DPR 25-18: Walmart Market Avon Avenue

Planning & Building Department Staff Report

For Hearing on March 23, 2026

F. ACTION REQUESTED	Request for approval of a Development Plan Review to allow for construction of a 50,074-square foot retail building, with a drive-through pharmacy, surface parking, and related improvements, with a Waiver of Design Standards of UDO 7.21(E)(1) to allow for a new full-access commercial driveway on Avon Avenue, being ~260 and ~320 feet from existing street intersections (minimum 400-foot separation required), and Waivers of Development Standards of 6.10(C) to allow for excessive average parking lot lighting and excessive light spillage across property lines.

Exhibit B2 – Revised Site Plan (11-March-2026)

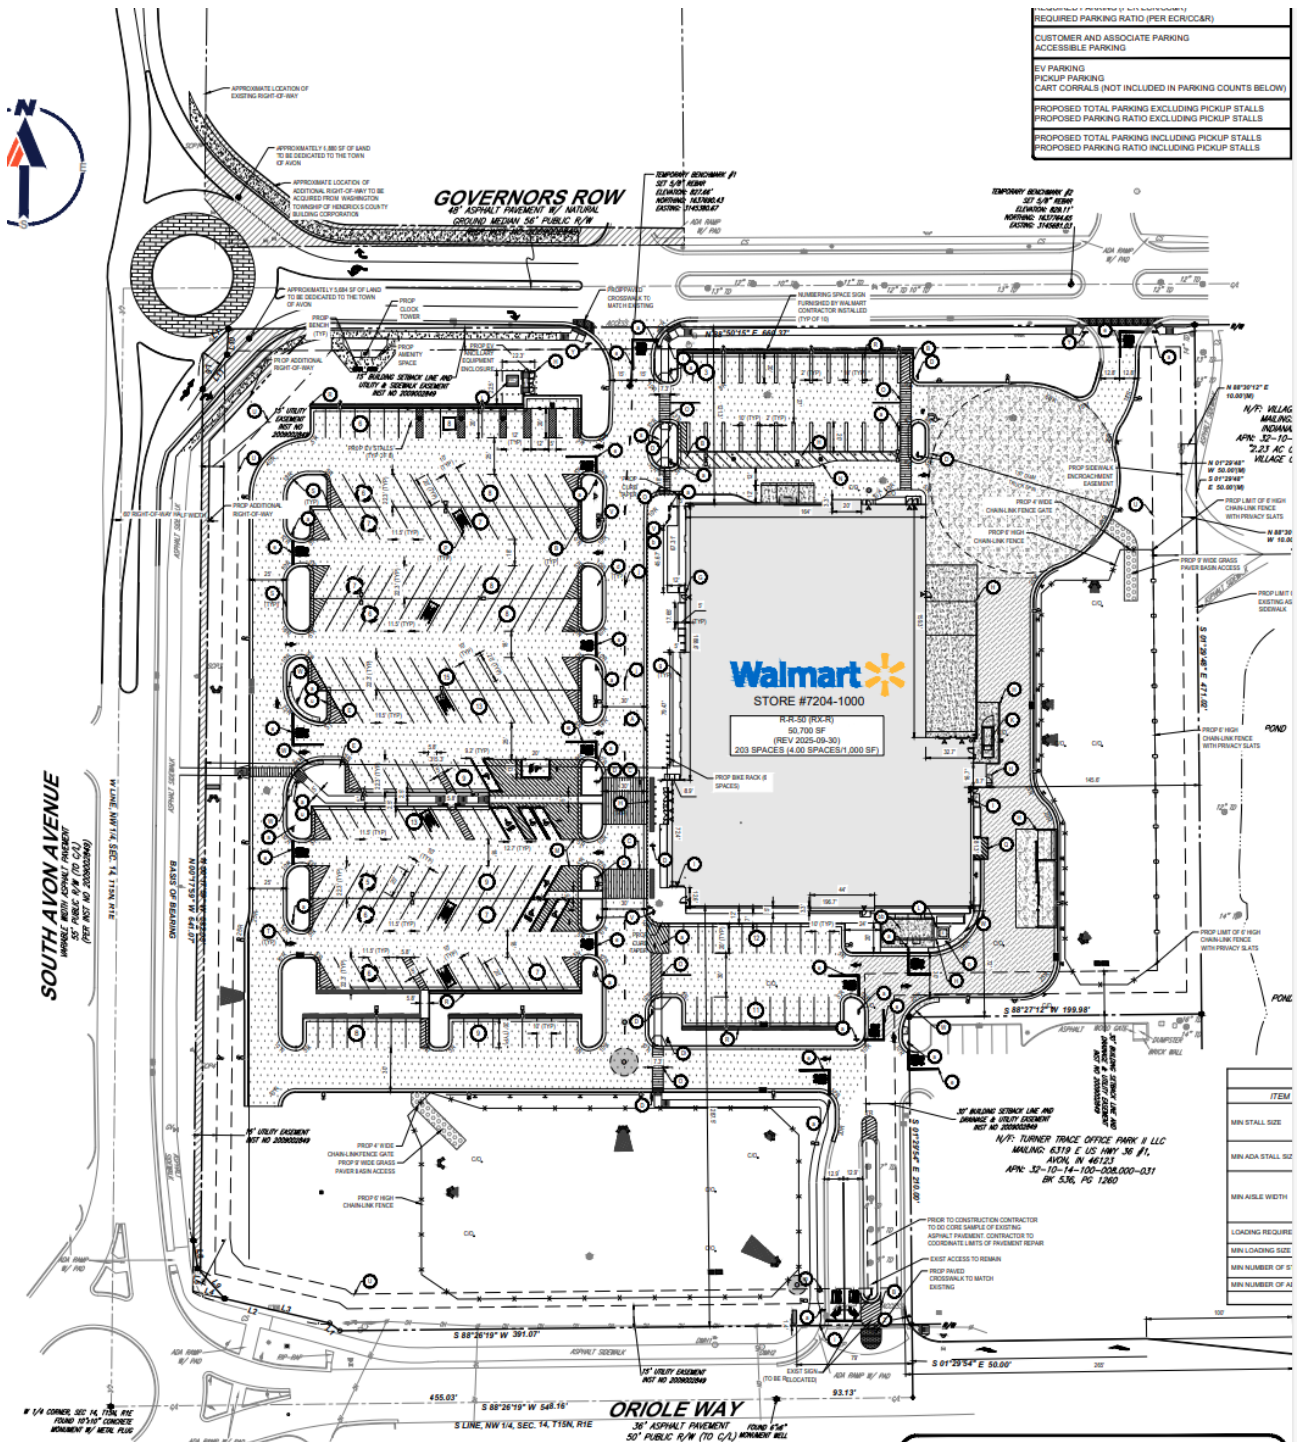
Revised site and landscape plans were submitted February 12, 2026 (see Exhibits B2 & C3) that address the issues raised by staff regarding bicycle racks, foundation plantings, interior parking lot landscaping, and the required site amenities. Additionally, more information was provided with the architectural plans to verify compliance with the glazing and roof requirements.

The revised site plan indicates a triangular median at the proposed Avon Avenue access point, which would be intended to prevent left turns to/from the site. A revised version of the petitioner's Traffic Impact Study (TIS) was submitted on February 9, 2026, which added a third scenario examining the proposed Avon Avenue access point as right-in, right-out only. Staff has consulted with the Department of Public Works and the Town's consulting engineer for review of the revised study.

c) **Bicycle Parking:** The UDO requires one bicycle rack per every twenty (20) required vehicle parking spaces, thus, six (6) bicycle racks would be required. While the revised site plan shows bicycle racks in a compliant location, the plan only indicates five racks. At least one additional rack would be required.

Exhibit C2 – Areas Deficient of Foundation Planting Requirement

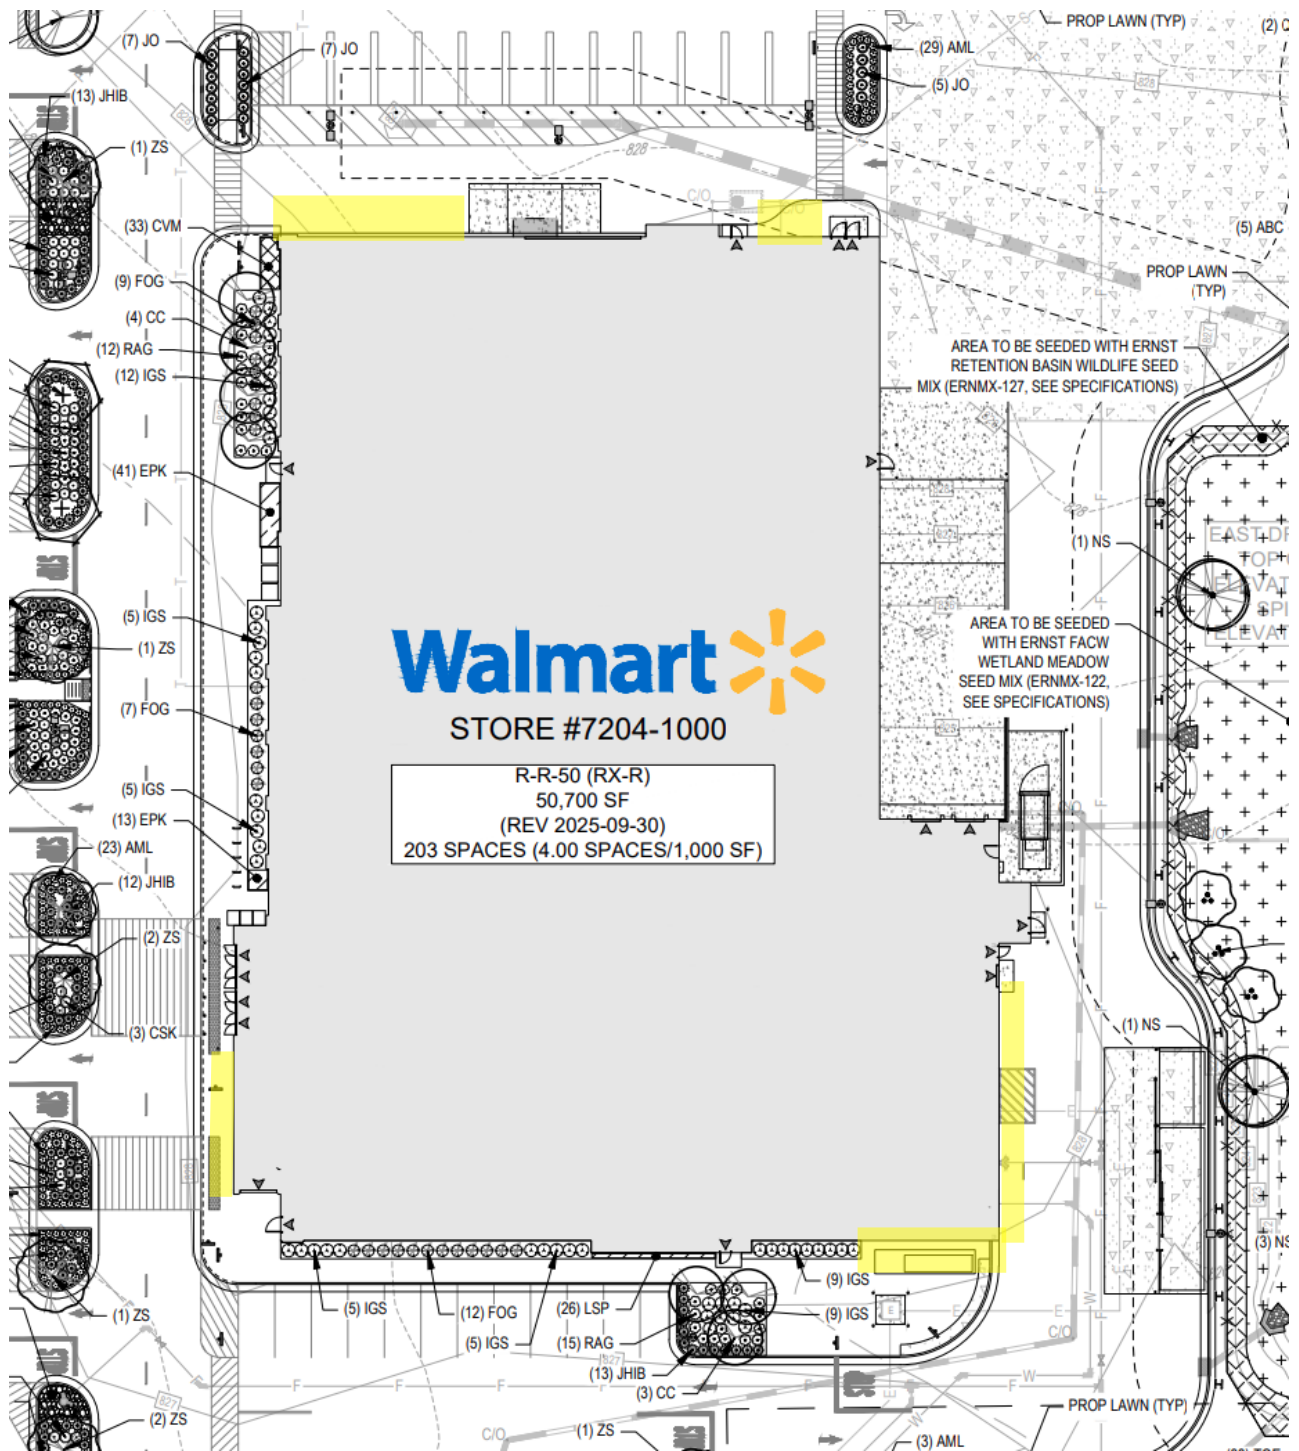
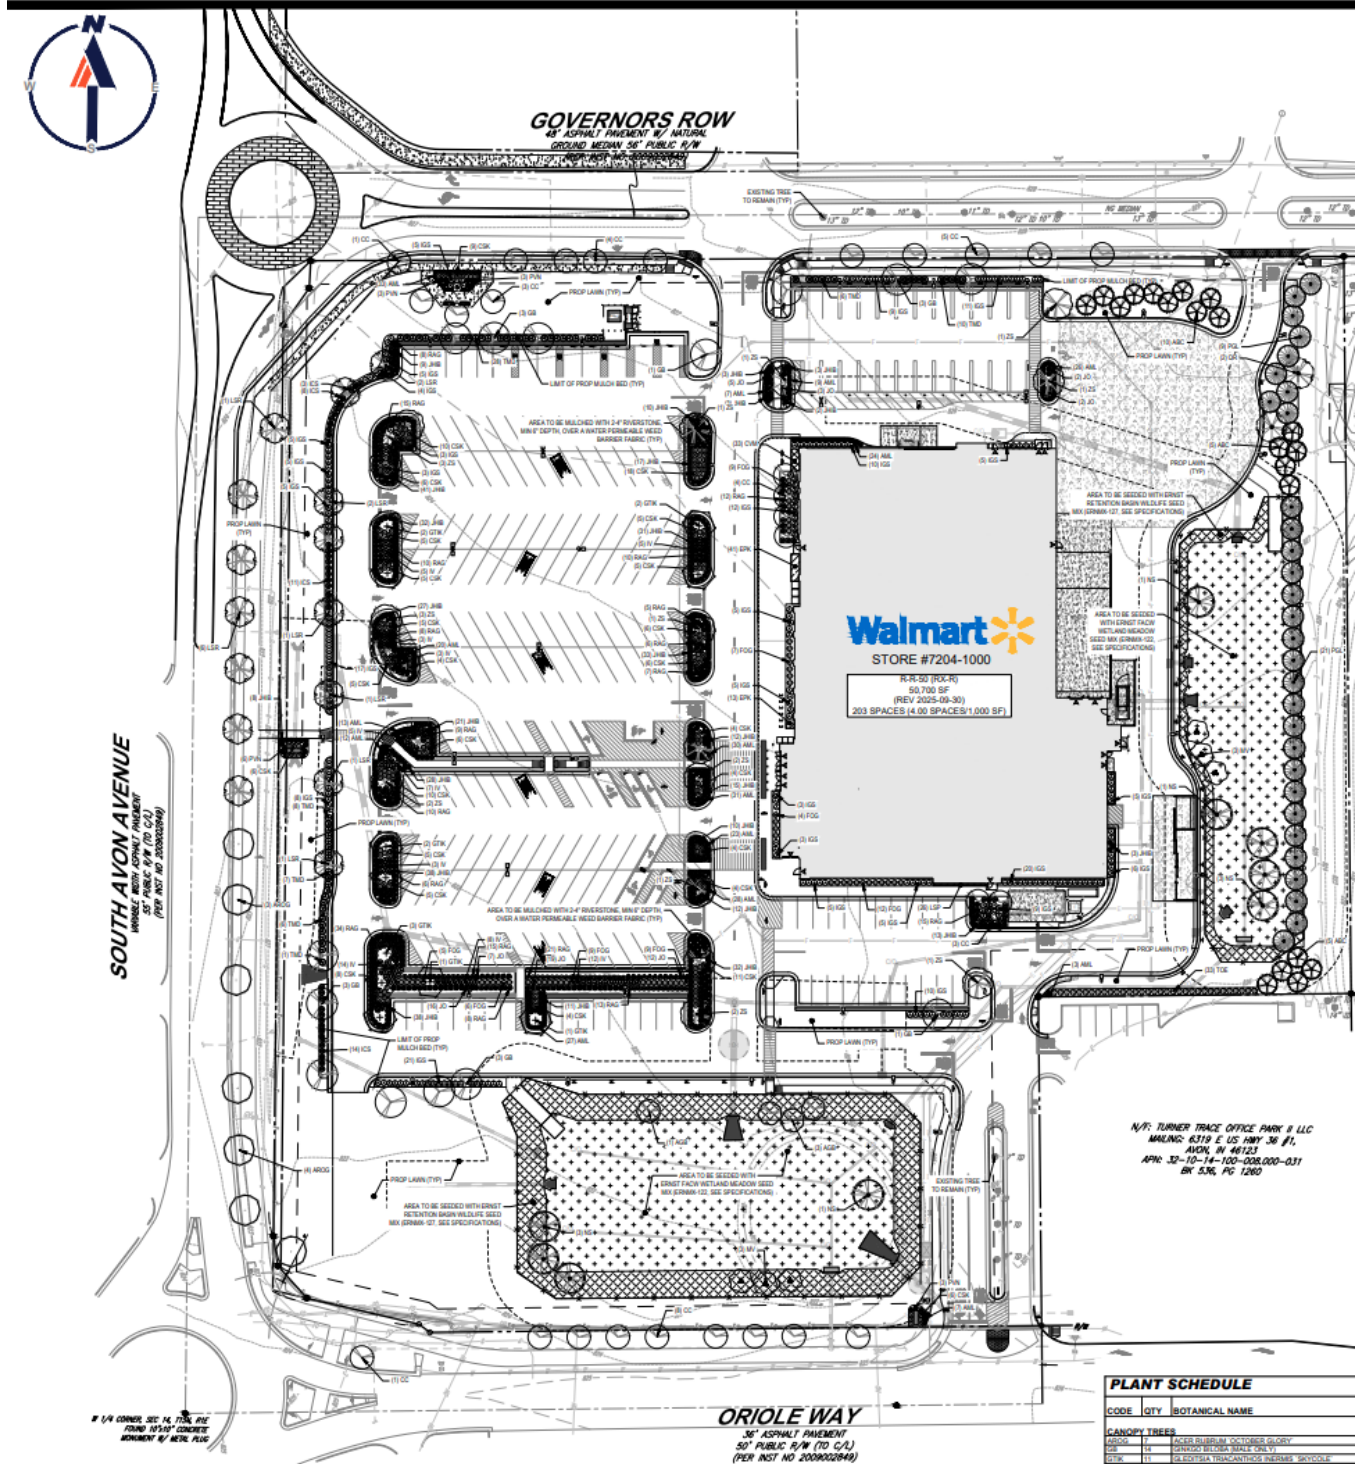
Per UDO 6.5 (A), a minimum five-foot planting area must be provided around the perimeter of the building, excluding access to the buildings, such as loading areas and doorways. The landscape plan submitted subsequent to TAC review has increased the proposed foundation planting areas, but is still deficient along several portions of the building (see Exhibits C1 & C2).

Per UDO 6.7(B)(4), each parking lot landscape island must have a minimum of one tree. The revised landscape plan is still deficient of this standard.

A further revised landscape plan should be submitted to demonstrate compliance with the foundation planting and interior parking lot landscaping requirements.

2. Prior to issuance of a building permit, a revised landscape plan shall be submitted, requiring approval by the Administrator, indicating compliance with all landscaping standards of the UDO.

Exhibit E – Aerial Photo w/ Measurements of Proposed Driveway Separation

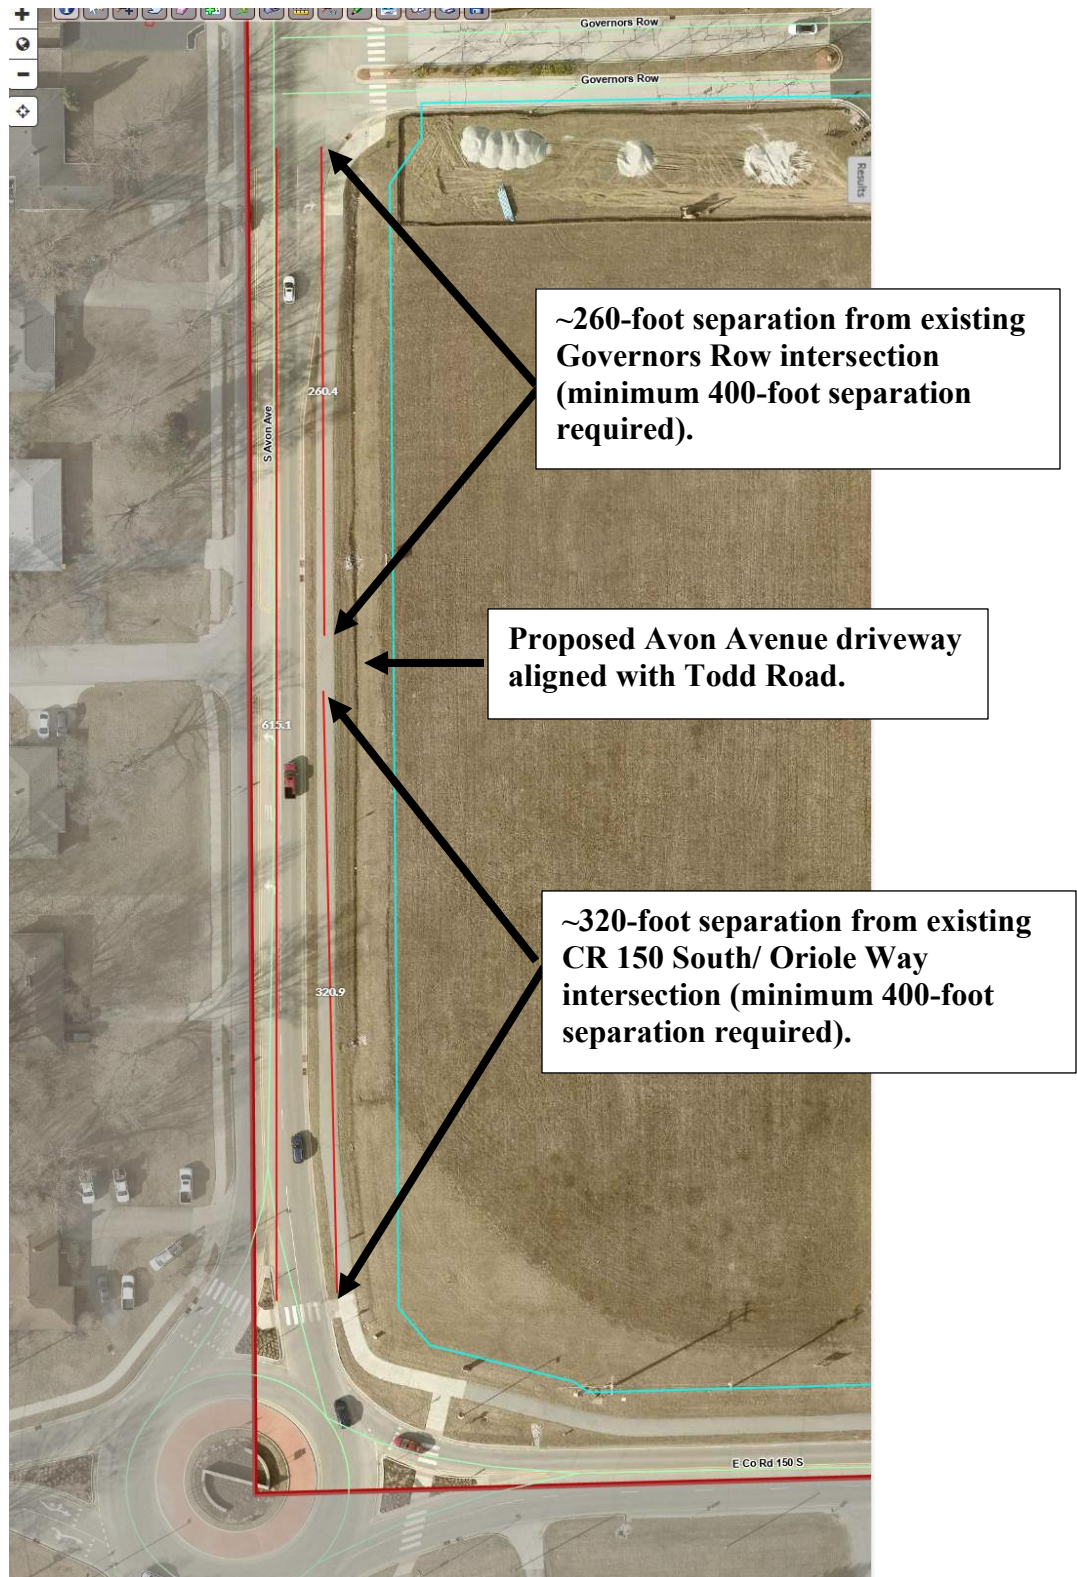
Waiver of Design Standards of UDO 7.21(E)(1), to allow for a new full-access commercial driveway onto Avon Avenue being ~260 feet from Governors Row and ~320 feet from County Road 150 South/ Oriole Way (minimum 400-foot separation from each existing intersection required).

It is the opinion of the Town's Public Works Director and consulting traffic engineer that inadequate spacing of intersections along an arterial street with a 45 MPH speed limit would increase the risk of collisions and injuries. Staff believes this finding would not be met.

The Town's consulting traffic engineer indicates that, in addition to not meeting the Town's minimum standard, the proposed alternative would also be deficient of the 360-foot separation standard for a 45 MPH roadway that is indicated in INDOT's Driveway Permit Manual. Staff believes this proposal does contradict the intent of the Town's public street and access design standards.

While the property's frontage is not lengthy enough to meet the separation standards for a new direct access point to Avon Avenue, the site is already served by driveways onto County Road 150 South/ Oriole Way and onto Governors Row, both of which provide full access to/from Avon Avenue.

The existing Todd Road intersection was constructed several decades ago prior to incorporation of the Town of Avon. Adding a tenfold increase in traffic turning onto Avon Avenue at the peak hour, as the petitioner's Traffic Impact Study indicates, would decrease traffic safety and flow. Thus, the proposed waiver would not enhance the surrounding area.

Staff recommends denial of this waiver request.

Exhibit F – Lighting Plan

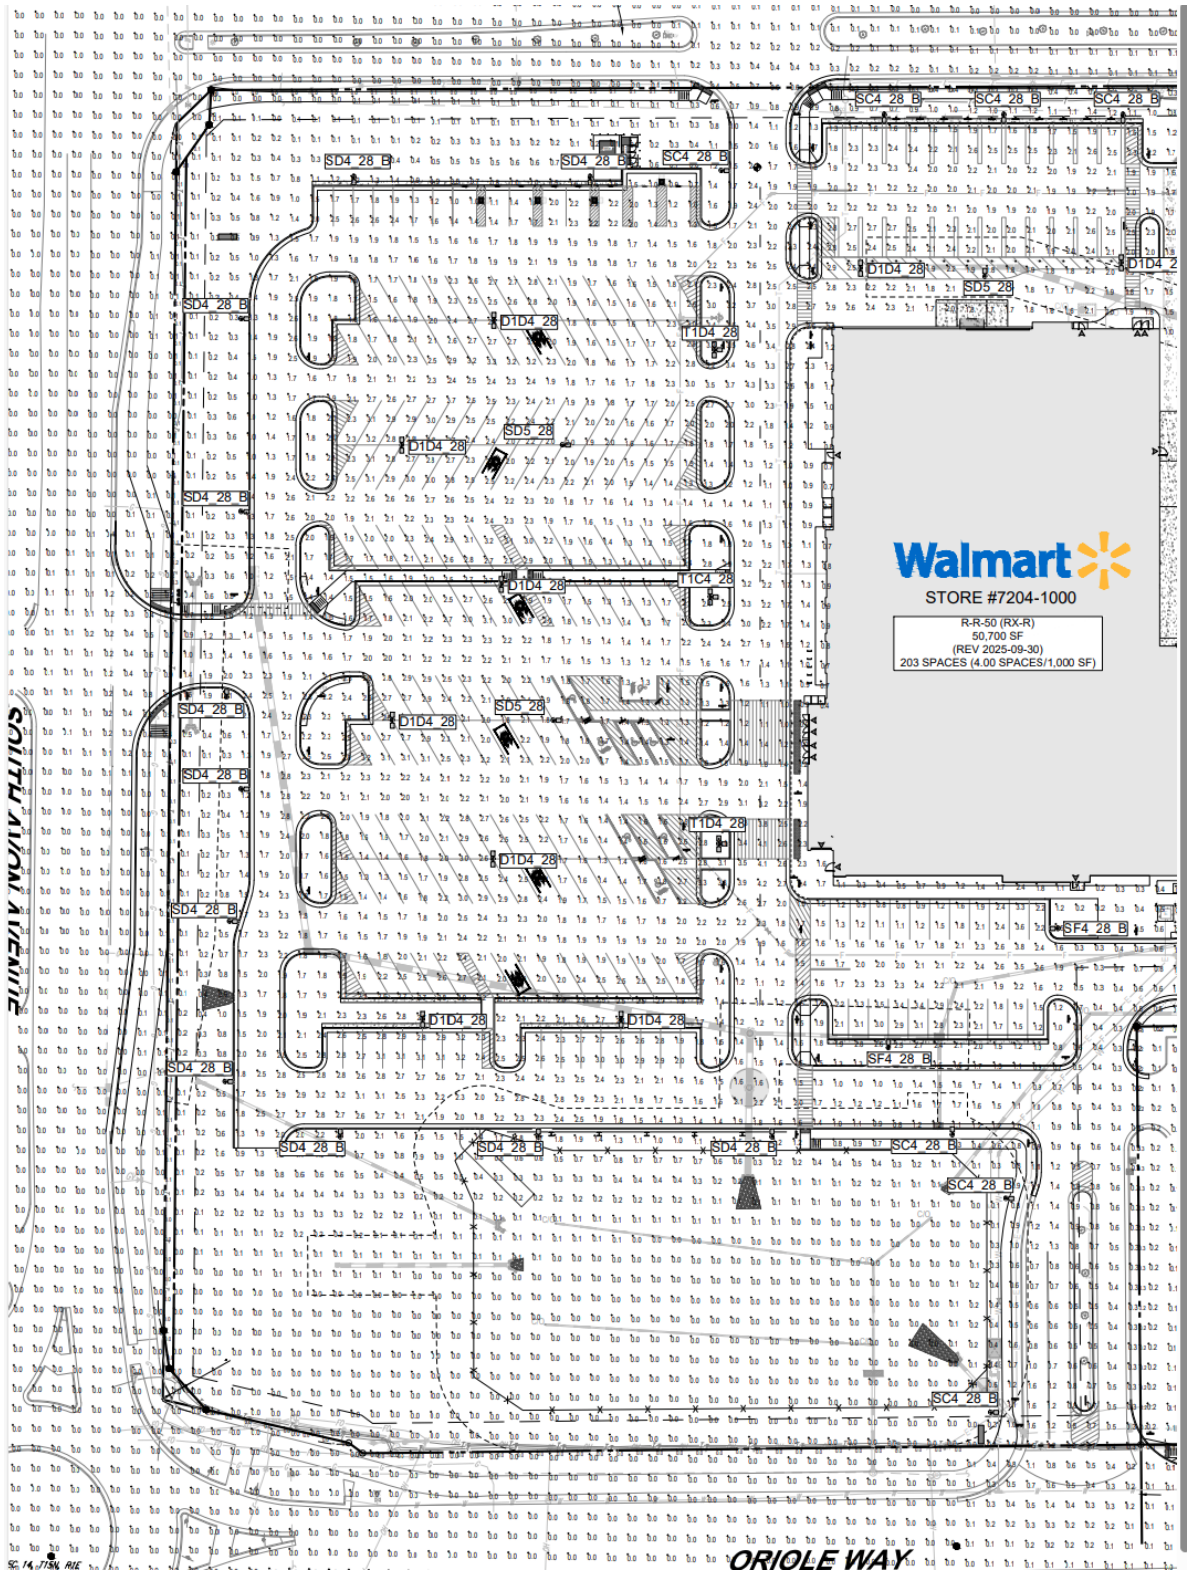
Two waivers of development standards have been requested to allow for excessive parking lot lighting and excessive light spillage into rights-of-way (see Exhibit F), which is discussed later in this report.

Waiver of Development Standards of UDO 6.10(C), to allow an average parking lot lighting level of 2.16 foot-candles (Fc), which exceeds the 1.6 Fc maximum average allowed.

The Town's lighting standards allow for a range of lighting levels, and the 1.6 Fc maximum average is in line with the recommendation of the IES, which recommends an average lighting level of 1.0 Fc for parking lots in suburban settings. Excessive lighting adds to light pollution, which can have negative impacts upon the public such as diminishing the quality of night sky views.

Because most developments comply with the standard, it is staff’s opinion that an average lighting level 35% higher than the maximum allowable level would not be harmonious with the purpose and intent of the zoning district.

Staff does not believe that a parking lot brighter than the allowable level would enhance the surrounding area, which predominantly consists of single-family dwellings.

For the reason stated above in Finding #3, staff disagrees with the petitioner’s assertion that this finding would be met. While all surrounding properties would be impacted by the excessive lighting level, the impact upon the low-density single-family dwelling properties across Avon Avenue to the west and across County Road 150/ Oriole Way to the south would likely be the most pronounced.

Waiver of Development Standards of UDO 6.10(A), to allow light spillage of 0.4 foot-candles (Fc) into the abutting rights-of-way, which exceeds the 0.3 Fc maximum allowed.

Staff concurs with the petitioner’s assertion that this is a minor deviation, and the Town is generally not opposed to slightly higher light spillage at an intersection (see Exhibit F).

A revised lighting plan indicating an allowable average parking lot lighting level has not been submitted. Therefore, **staff's recommendations for Waivers B & C remain as indicated in the January 26, 2026 staff comments.**

Staff recommends denial of this waiver request.
